Re: Response to Technical Review Committee Comments
Application No. 276
Seton Hall University – University Center
Block 901, Lot 3
Langan Project No.: 100898001

The following is in response to the comments provided by the Planning Board's professionals during the Technical Review Meeting on 12 January 2021 for the Seton Hall University Center Amended Site Plan Application. Comments have been identified in italics and associated responses are in bold. Accompanying this letter are copies of drawings that have been revised to address the comments. A full list of the enclosures is provided at the end of this letter

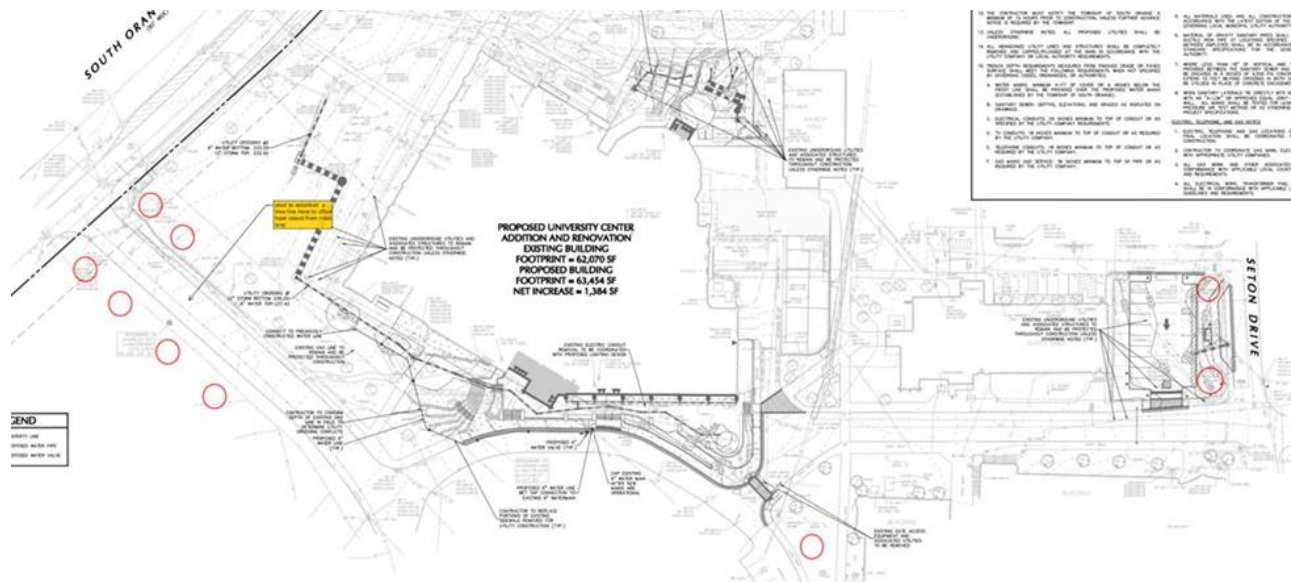
10. *Request for additional shade trees. Shrubs / wall should buffer headlight glare from streets.*

In response to comments from the Board's professionals, additional shade trees will be provided as per the sketch below. Additionally, shrubs will be provided behind the bus shelter and between the new shade trees to help screen headlight glare from the streets that may occur as suggested.
